ADDENDUM

PROJECT: Lucas County Sanitary Engineer's Office
Addition to Vehicle Building 'B'

ADDENDUM NO.: 1

PROJECT NO.: 140208

ADDENDUM #1 - MECHANICAL ITEMS

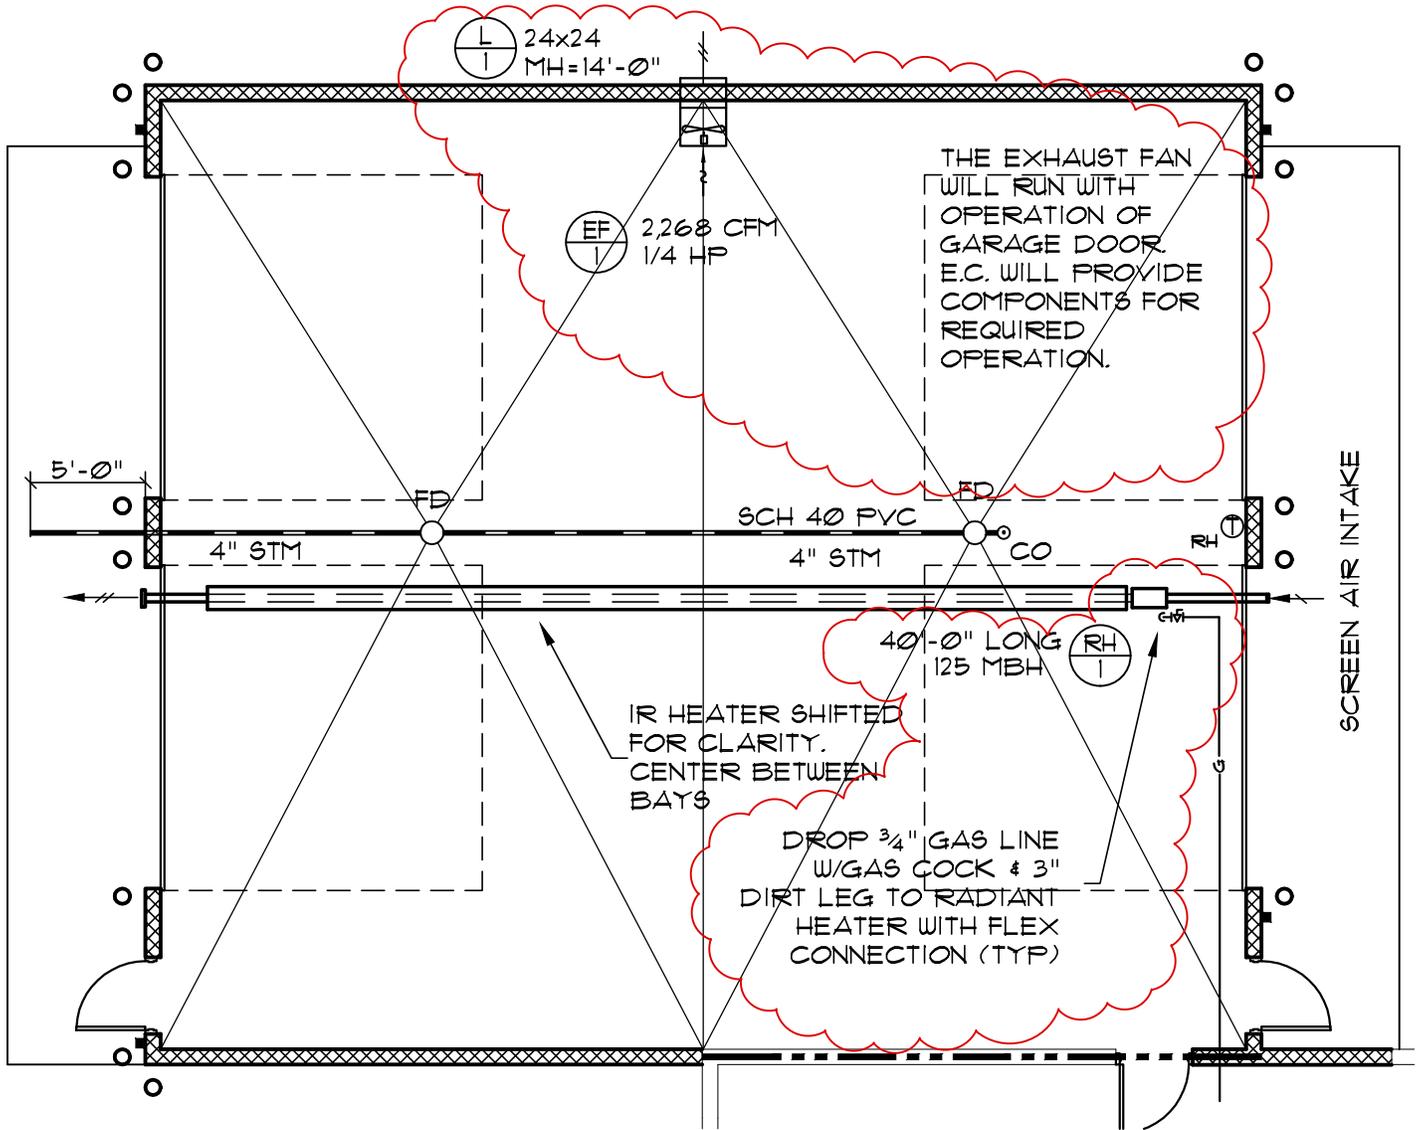
- Provide an exhaust fan and louver in new building addition, the same model for both base bid and alternate. See attached drawing "Addendum 1- Mechanical items" for more information.
- Provide a gas connection to the infrared heaters as noted on attached drawing "Addendum 1- Mechanical items".

ADDENDUM #1 - ELECTRICAL ITEMS

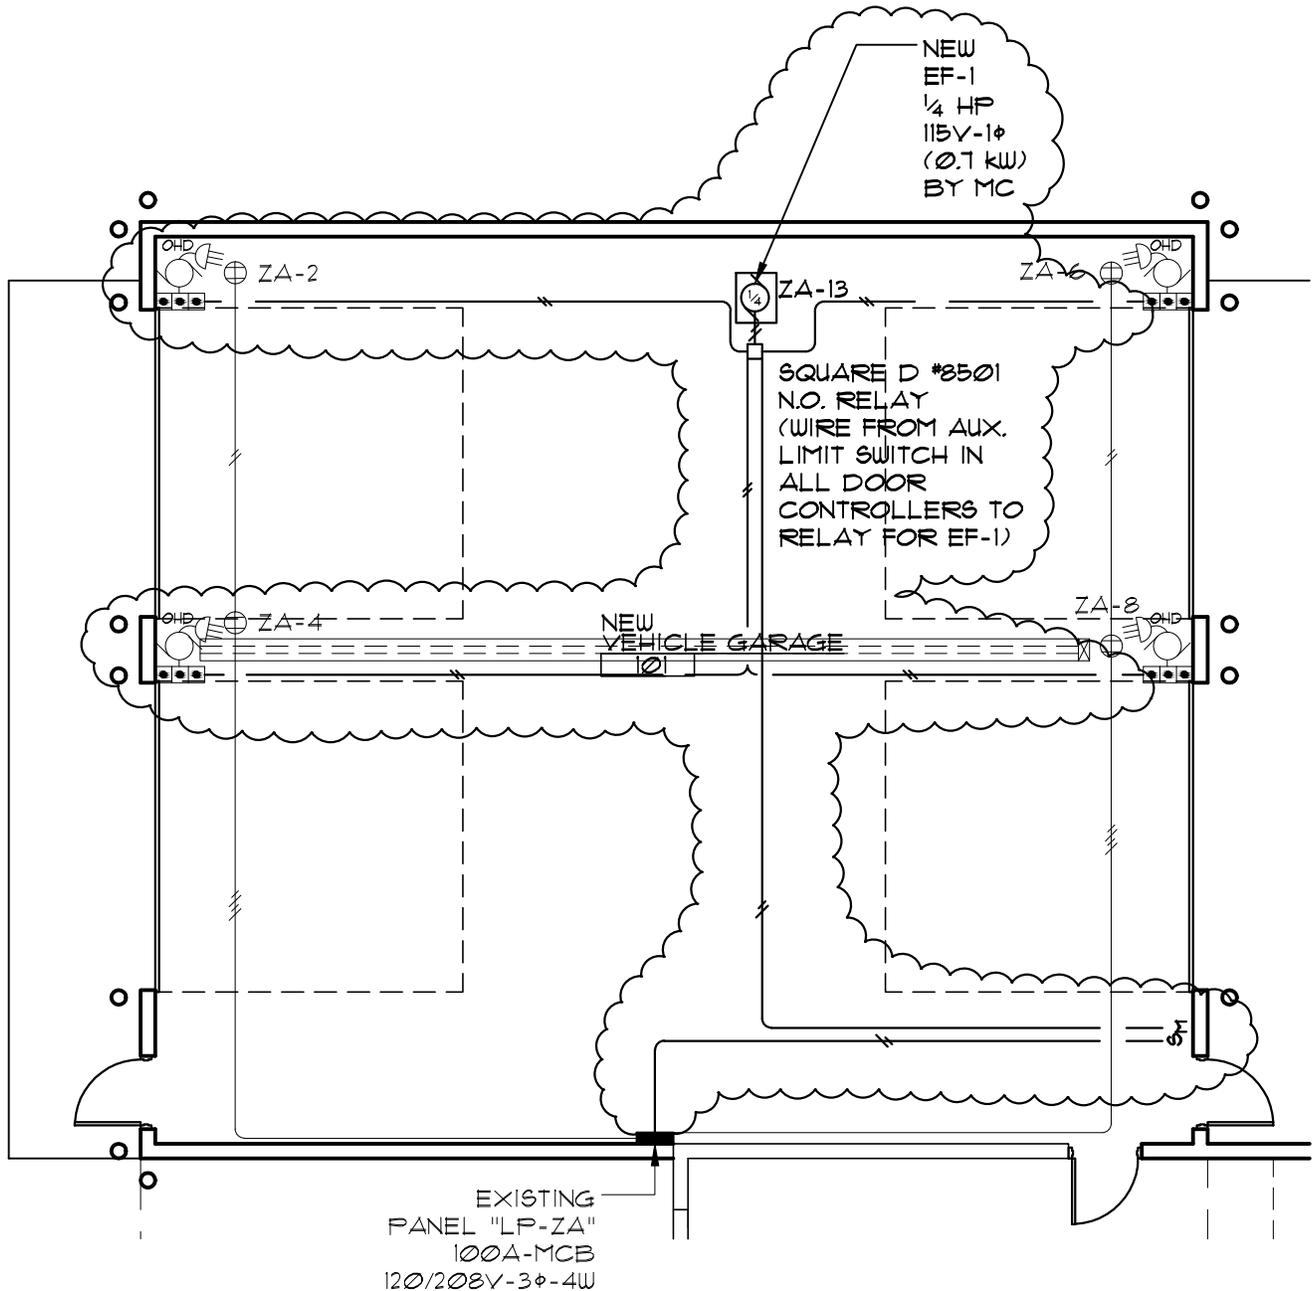
- Provide power for EF-1 (provided by M.C.). Provide labor and materials to install (1) one Square D #8501 N.O. Relay and (1) one manual motor starter switch. Utilize existing 20A-1P spare breaker in existing panel LP-ZA. The relay shall be installed near EF-1 surface mounted to the ceiling above in a NEMA 1 enclosure and wired from auxiliary limit switch in all door controllers to relay for EF-1. See "Addendum #1 – Electrical Items" for details.
- Provide grounding to metal siding as required by the NEC.
